Product Change Notice

Affected Part Numbers:

2000-1207

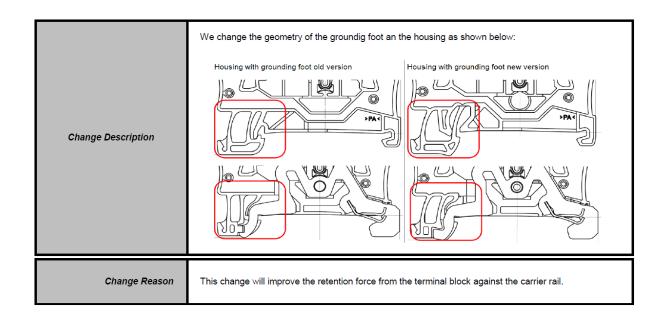
The change in the foot design of the series was necessary to achieve the EX approval of the terminal blocks.

These changes should have no effect the in use or efficiency of the products.
